Access Compliance Report

Public Rights-of-Way

Intersection ID: 5708	Main Street: PLEASANT GROVE RD	Cross Street: OAKDALE GREEN DR	Location: S
ADA ID: 0D6065413A0B	Ramp Type: BlendTrans1	Initial Pass/Fail: Fail	Overall Compliance: No
		Severity Score: 8.75

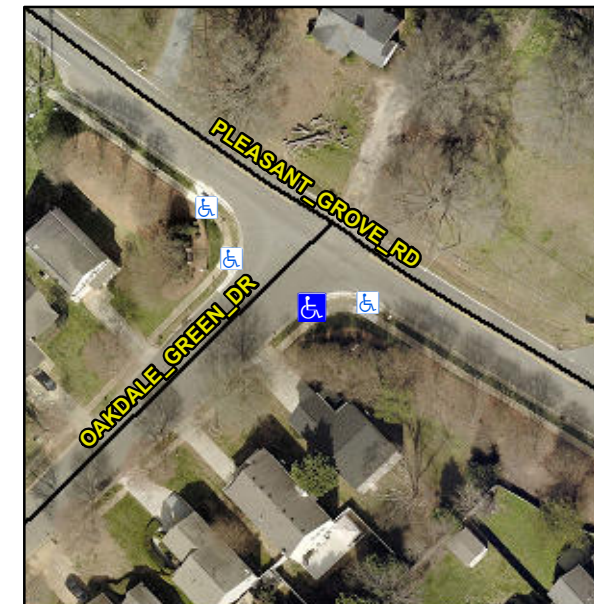
Compliance	Description	Data	Compliance	Description	Data
N/A	Ramp Length (in)	47.0	Yes	BlendTrans Slope (%)	0.9
No	Ramp Width (in)	39.0	Yes	BlendTrans XSlope (%)	0.3
N/A	Flare Type LT	N/A	N/A	Flare Type RT	N/A
N/A	Flare Slope LT (%)	N/A	N/A	Flare Slope RT (%)	N/A
N/A	Flare Traversable LT?	N/A	N/A	Flare Traversable RT?	N/A
N/A	Landing Length (in)	N/A	N/A	DWS Provided?	N/A
N/A	Landing Width (in)	N/A	N/A	DWS Contrast?	N/A
N/A	Landing Slope (%)	N/A	N/A	DWS Length (in)	N/A
N/A	Landing X Slope (%)	N/A	N/A	DWS Full Width?	N/A
N/A	Landing Curb? (Y/N)	N/A	N/A	DWS Offset (in)	N/A
N/A	Shared Landing?	N/A			
N/A	Gutter Ponding?	N/A	N/A	Gutter Slope (%)	N/A
N/A	Gutter Lip Ht (in)	N/A	N/A	Gutter X Slope (%)	N/A
N/A	Painted X Walk1?	No	N/A	Painted X Walk2?	N/A
	X Walk 1 Direction	To NW		X Walk 2 Direction	N/A
	X Walk 1 Width (in)	N/A		X Walk 2 Width (in)	N/A
	X Walk 1 Slope (%)	0.2		X Walk 2 Slope (%)	N/A
	X Walk 1 X Slope (%)	0.9		X Walk 2 X Slope (%)	N/A

Remove & Replace Curb Ramp With Two New Directional Ramps or Equivalent.

R304.5.1
